Sub-Committee of Experts on the
Globally Harmonized System of Classification
and Labelling of Chemicals
(Fourth session, 9-11 December 2002,
agenda item 2)

EDITORIAL COMMENTS on the GHS

Part2 PHYSICAL HAZARDS (ST/SG/AC.10/C.4/16/Add.2) and ANNEX 1 Allocation of Label Elements (ST/SG/AC.10/C.4/16/Add.4)-

Transmitted by the expert from Canada

Figures 10.2 and 10.3 (*UN Recommendations on the Transport of Dangerous Goods, Manual of Tests and Criteria*)

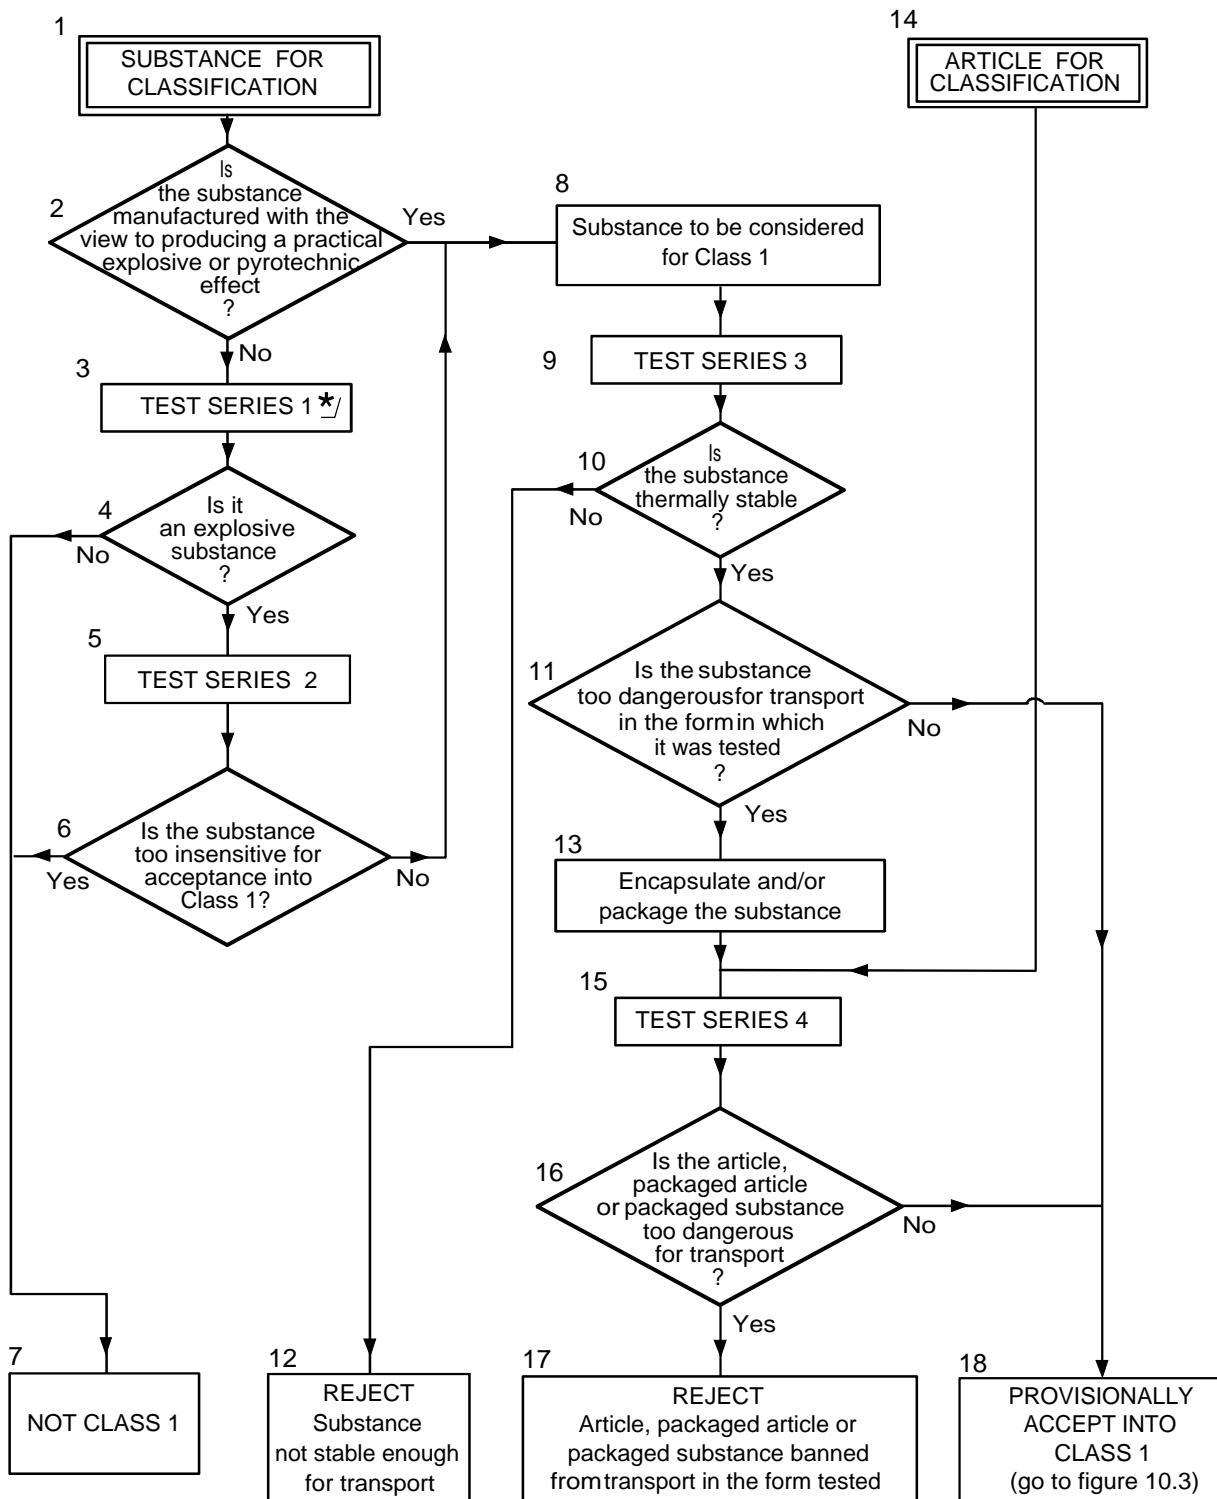
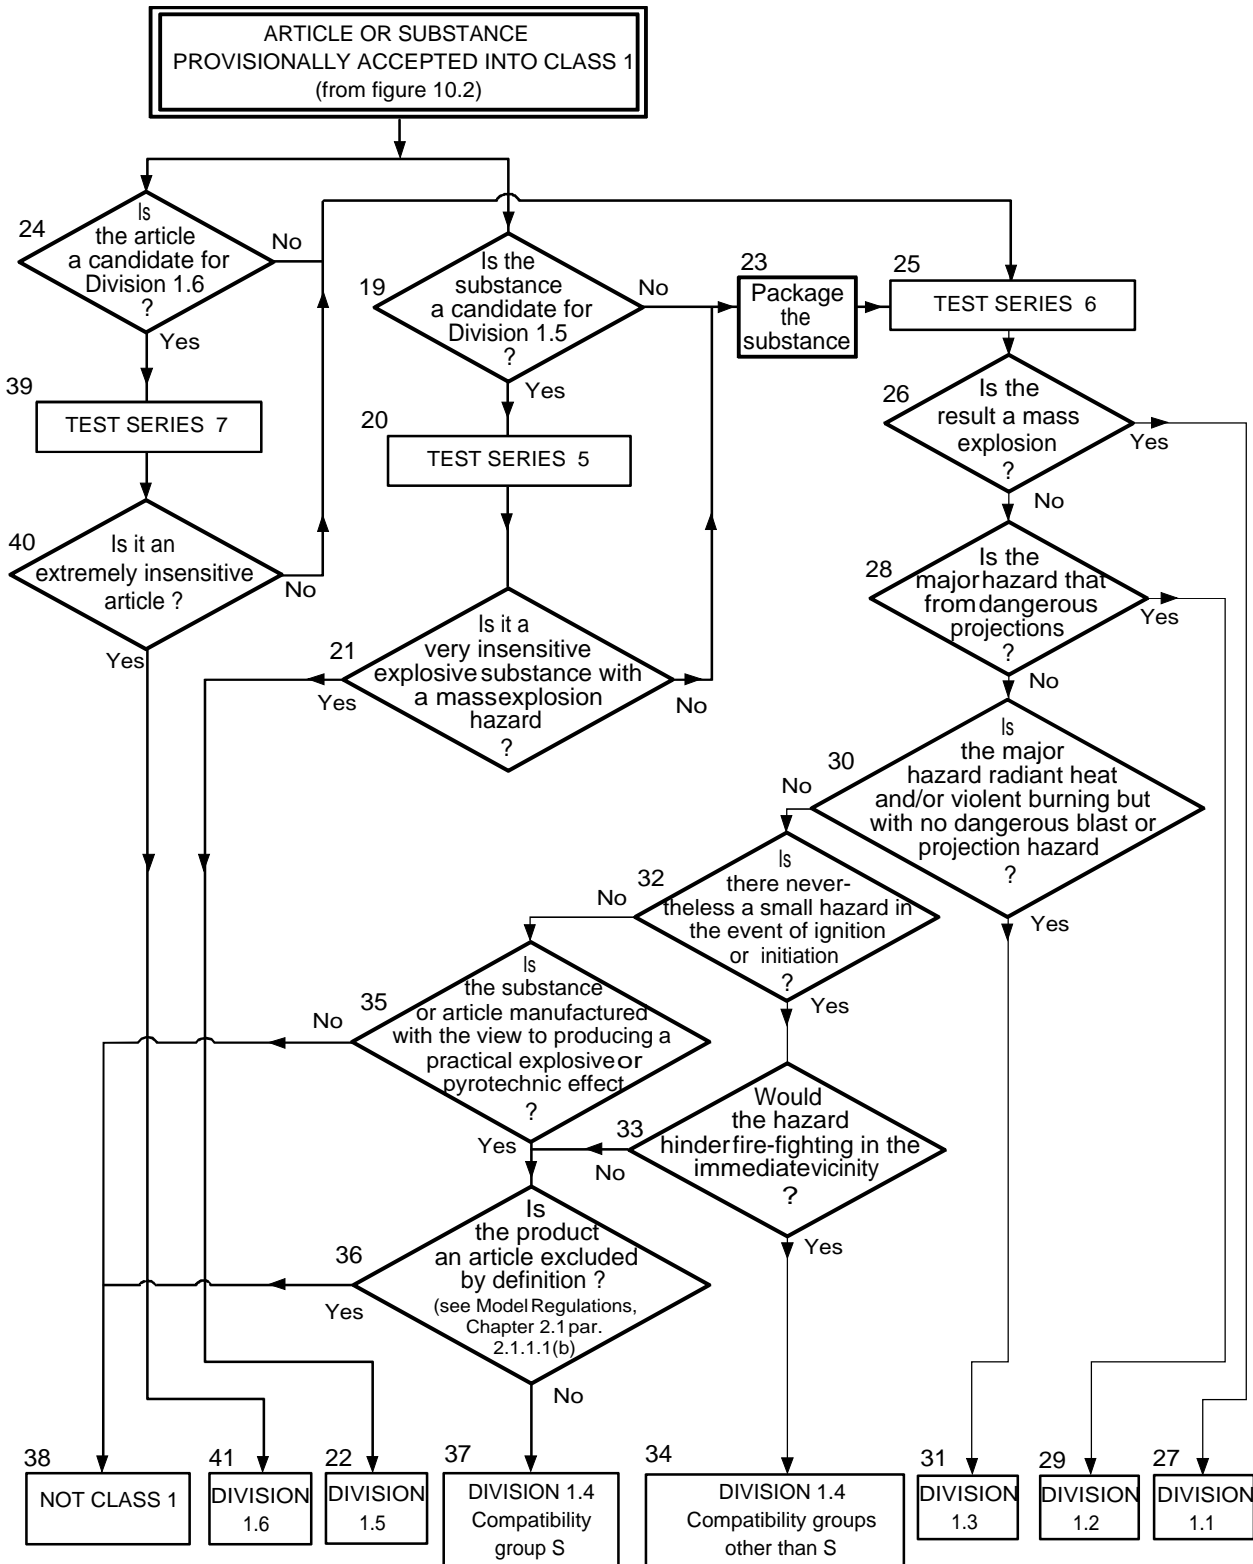
1. Decision charts were reproduced from the *UN Recommendations on the Transport of Dangerous Goods, Manual of Tests and Criteria*. Specifically, these appear as **Figures 2.1.2** and **2.1.3** in **CHAPTER 2.1**, *Decision logic 2.8* in **CHAPTER 2.8**, and *Decision logic 2.15* in **CHAPTER 2.15**.

2. When these figures were redrawn, all decision arrows were made to intersect whereas some arrows in the *Manual of Tests and Criteria* were intended to 'cross over' rather than intersect. An example of this can be seen in ANNEX 1, **Figure 10.2**, where the "NO" arrow from BOX 11 'crosses over' the "Decision" from BOX 14.

3. ANNEX 1 contains **Figures 10.2** and **10.3** (corresponding to **Figures 2.1.2** and **2.1.3**) from the *Manual of Tests and Criteria*. ANNEXES 2 and 3 contain equivalent figures from the *UN Recommendations on the Transport of Dangerous Goods, 12th Revised Edition* (corresponding to *Decision logics 2.8* and *2.15*).

1. Modify **Figures 2.1.2** and **2.1.3**, *Decision logic 2.8* and *Decision logic 2.15* to show the 'cross overs' as indicated in ANNEXES 1-3 figures to this paper.
